MEMO

TO: William Bartley
FROM: Helen Jones
SUBJECT: Mordialloc EES Post-Panel Questions
OUR REF: PS101340-592-HAJ-MEM-1 Rev0
DATE: 14 March 2019

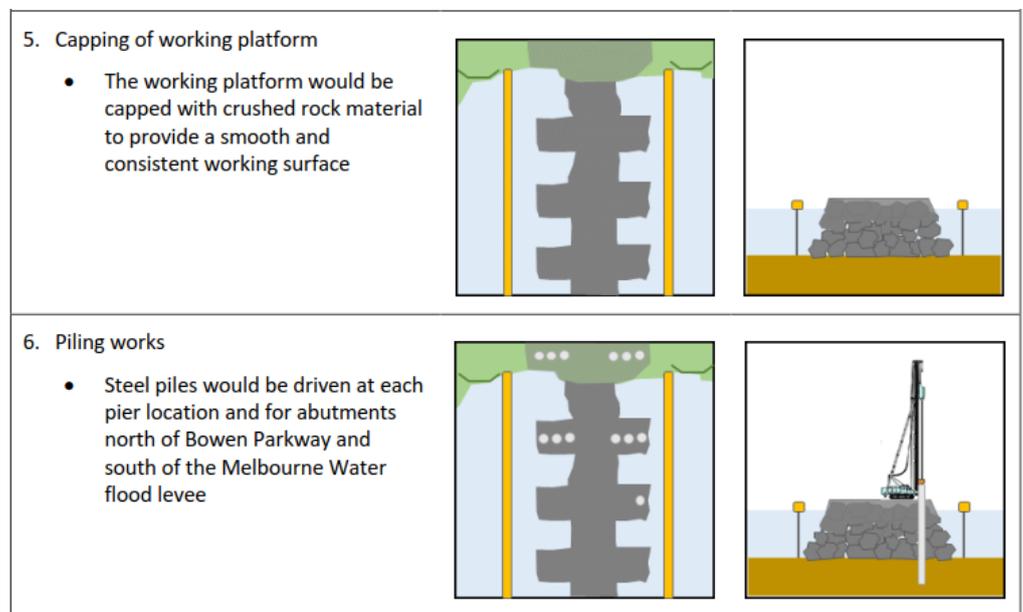
Clarification opinion: The construction of the bridge over the Waterways Wetlands could encounter Acid Sulfate Soils (ASS) that if exposed to air could oxidise and potentially impact water quality if not managed appropriately.

The above extract is taken from the technical note and depicts the working platform and driven pile installation. The water in the wetlands remains present due to the porous nature (crushed rock) of the working platform. This would effectively maintain moisture content in the soils and inhibit oxidation. Water quality in terms of pH would only be impacted if soils were left to oxidise. This situation would be mitigated by the proposed approach.

The current design employs a minimisation approach whereby disturbance will occur through piling but that this would be undertaken in a controlled environment (as noted above).

If soils are needed to be exhumed from beneath the water table, then these soils would need to be either directly removed from the area and either stored in an engineered management area prior to treatment with ag lime or removed directly to landfill. The containment would need to consider surface water interaction and mitigate overland flow from the area. pH impact on water could only occur if oxidised soil is permitted to interact with surface water (e.g. through runoff or direct exposure). Containment areas would therefore need to be designed to mitigate this and be placed at a suitable distance from the waterways.
